# Access Compliance Report

## Public Rights-of-Way

### (Curb Ramps)

Intersection ID: 3825	Main Street: GARRISON_RD	Cross Street: LADORA_DR	Location: W
ADA ID: 57E980CEDEA8	Ramp Type: PerpDiag	Initial Pass/Fail: Fail	Overall Compliance: No
Severity Score: 46.25			
Codes/Mitigation Info/Possible Solution		Field Measurements/Component Compliance

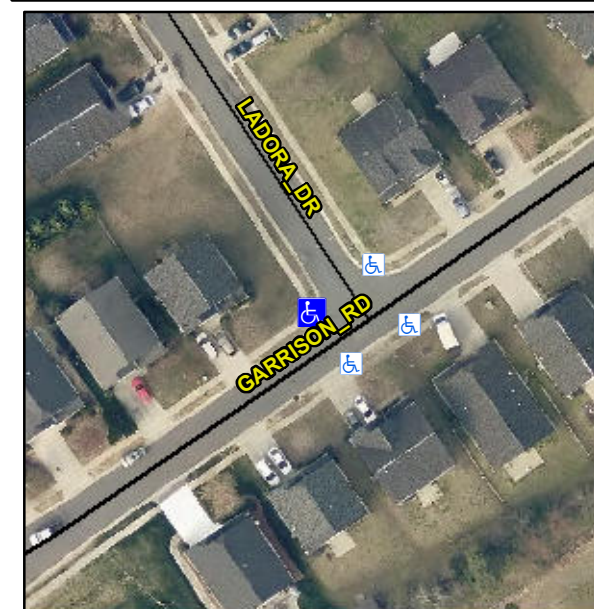
**Not Found, R304.5.1, R304.2.2, R304.5.3**

Compliance	Description	Data	Compliance	Description	Data
N/A	Ramp Length (in)	51.0	No	Ramp Slope (%)	9.0
No	Ramp Width (in)	39.0	No	Ramp XSlope (%)	10.1
N/A	Flare Type LT	N/A	N/A	Flare Type RT	N/A
N/A	Flare Slope LT (%)	N/A	N/A	Flare Slope RT (%)	N/A
N/A	Flare Traversable LT?	N/A	N/A	Flare Traversable RT?	N/A
N/A	Landing Length (in)	N/A	N/A	DWS Provided?	N/A
N/A	Landing Width (in)	N/A	N/A	DWS Contrast?	N/A
N/A	Landing Slope (%)	N/A	N/A	DWS Length (in)	N/A
N/A	Landing X Slope (%)	N/A	N/A	DWS Full Width?	N/A
N/A	Landing Curb? (Y/N)	N/A	N/A	DWS Offset (in)	N/A
N/A	Shared Landing?	N/A			
N/A	Gutter Ponding?	N/A	N/A	Gutter Slope (%)	N/A
N/A	Gutter Lip Ht (in)	N/A	N/A	Gutter X Slope (%)	N/A
N/A	Painted X Walk1?	No	N/A	Painted X Walk2?	No
	X Walk 1 Direction	To SE		X Walk 2 Direction	To NE
N/A	X Walk 1 Width (in)	N/A	N/A	X Walk 2 Width (in)	N/A
	X Walk 1 Slope (%)	8.5		X Walk 2 Slope (%)	0.1
	X Walk 1 X Slope (%)	3.0		X Walk 2 X Slope (%)	7.0

**Remove & Replace Curb Ramp With Two New Directional Ramps or Equivalent.**
